ADDENDUM 01 - ELECTRICAL

PROJECT: ENCSD Alford Hall HVAC Upgrades

PDC Project No. 22034 SCO # 22-24313-01

E1.00

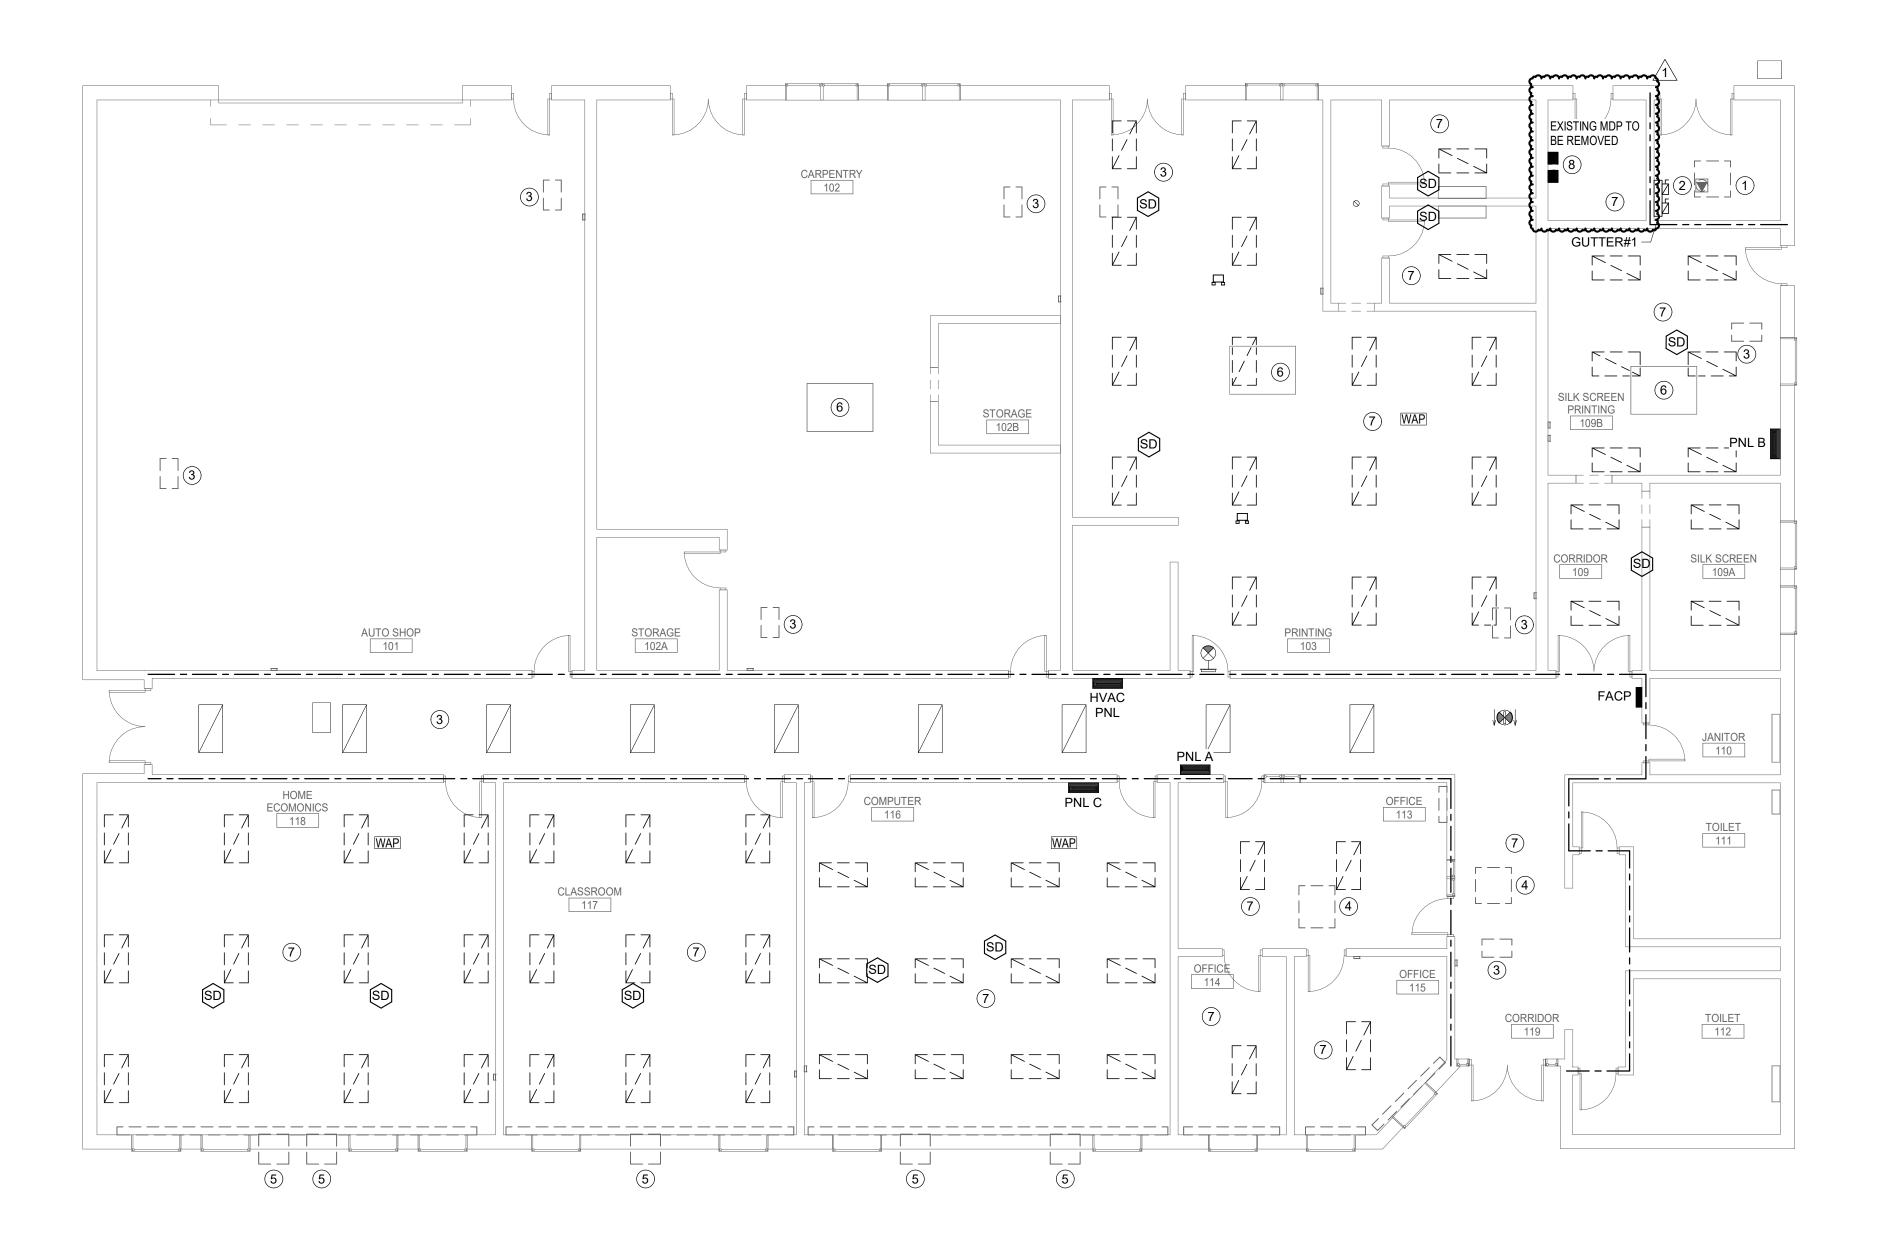
E1.00 – Added keynote to electrical 107 to remove lighting and ceiling mounted devices.

- 6. EXISTING ROOF TOP UNIT TO REMAIN IN PLACE.
- 7. REMOVE EXISTING CEILING GRID, LIGHTS, AND CEILING MOUNTED DEVICES AND STORE FOR ADDITION OF NEW DUCTWORK. KEEP ALL WIRING IN PLACE FOR RECONNECTION. PRESERVE EXISTING STRUCTURAL SUPPORTS, FIRE RATED BOXES AND OTHER ITEMS NOT DISTURBED BY DEMOLITION. PROVIDE SUPPORT FOR ANY CABLING NOT REMOVED VIA DEMOLITION OF EXISTING DEVICES. REMOVAL OF CEILING GRID AND REINSTALLATION IS PER BASE BID. ALTERNATE BID#1 IS FOR REMOVAL OF GRID AND REPLACEMENT WITH NEW GRID AND GRID TILE. REFERENCE SHEET G1.01

E2.00

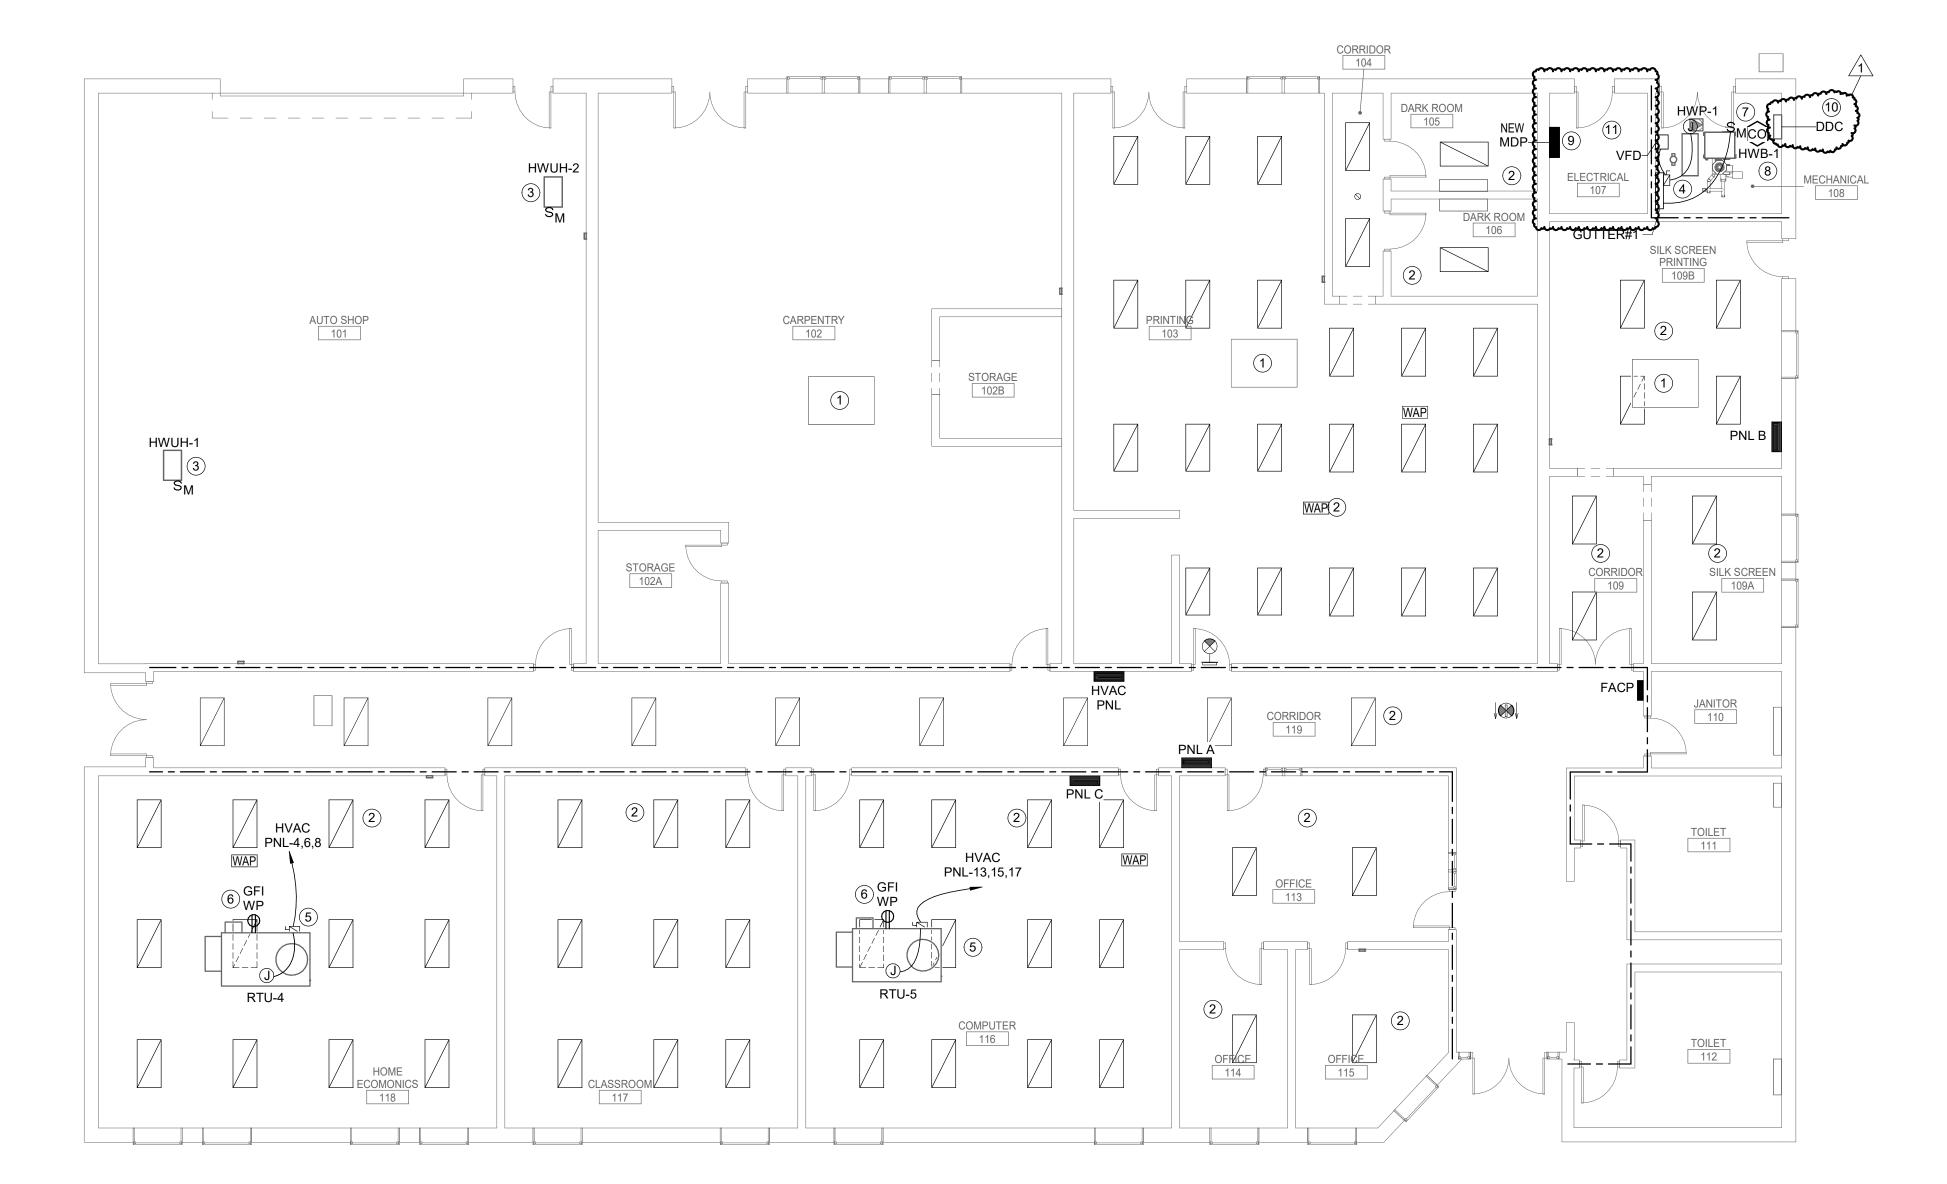
E2.00 – Added keynote 10 to list and mechanical room for new DDC Circuit, and Added keynote 11 to reinstall lighting and ceiling mounted devices to new gyp board ceiling.

- 10. PROVIDE 120V POWER CIRCUIT FOR DDC PANEL. PROVIDE ETHERNET DROP FOR SAME.
- 11. REINSTALL AND RECONNECT ALL LIGHTING AND CEILING MOUNTED DEVICES REMOVED IN DEMOLITION PHASE TO EXISTING WIRING LEFT IN PLACE. ENSURE ALL EXISTING ITEMS HAVE BEEN STORED AND ANY EXISTING CEILING CABLES, STRUCTURE SUPPORTS, AND FIRE RATED BOXES HAVE BEEN REINSTALLED WITH DEVICES AS REQUIRED.
